YOYLAND WEST - ADDENDUM

AIR QUALITY ASSESSMENT

VC-103210-AQ-RP-0003
R00

SEPTEMBER 2020

Figure 1 Modelling Locations

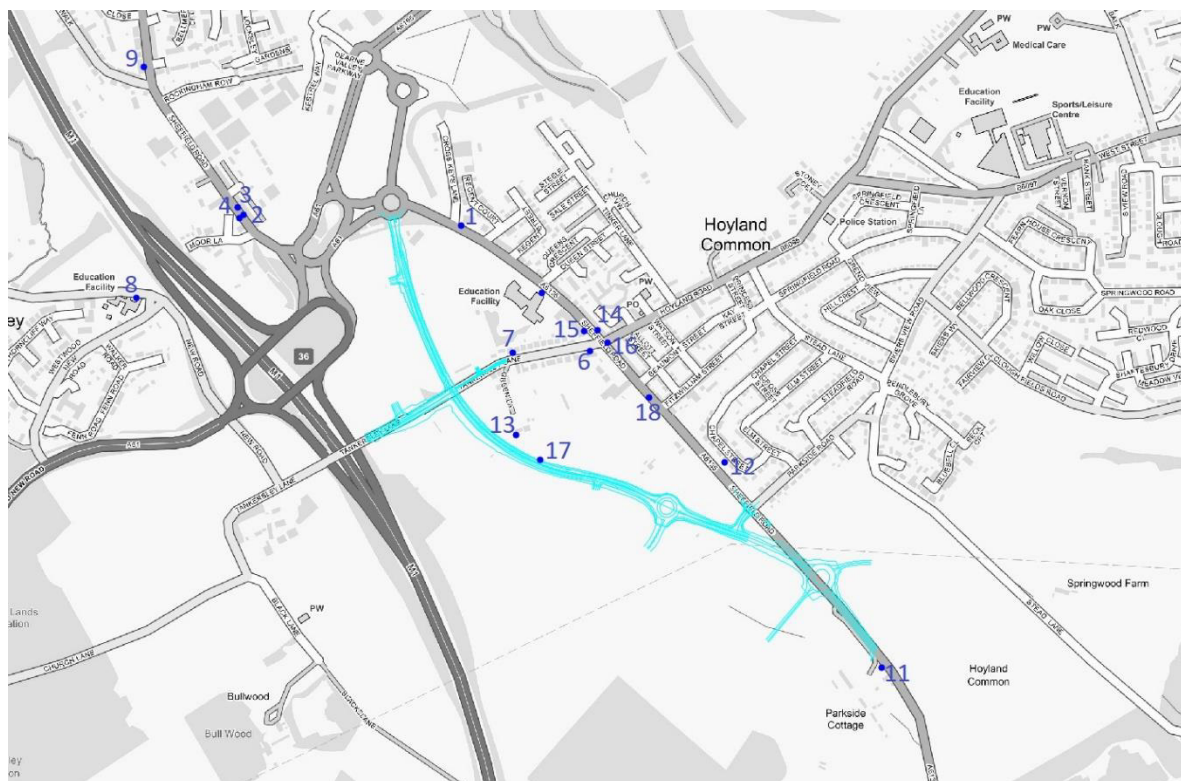
Further to the previously identified modelling receptor locations would receptor no.13 (E:435385 N:399957) suffice as a representative receptor location for the plot no.6 boundary to the link road. I can also add a receptor on the Sheffield Road side (E:435656 N:400033)? This will be considered within a sensitivity assessment (along with the operation of Hoylands south) Could you supply a map showing the location of receptor 13 in relation to plot 6 to confirm that receptor 13 is suitable? I have further reviewed the proposed modelling location and think the attached location (E: 435435 N: 399906) would offer a better worst case scenario than Receptor 13 (based upon the field boundaries and plots on <https://www.barnsley.gov.uk/media/14380/hoyland-consultation.pdf>).

2.10. The same modelling receptor locations as for the previous air quality assessment have been used, (to note, these receptor locations have previously been agreed with BMBC). For completeness these are described in Table 1 and illustrated in Figure 1. To note, two further receptors has been considered (no(s).17 & 18) for the cumulative assessment, to consider the future air quality concentrations at Plot 6 of the Hoylands West Masterplan, which is identified as residential. These additional receptor locations were agreed with BMBC.
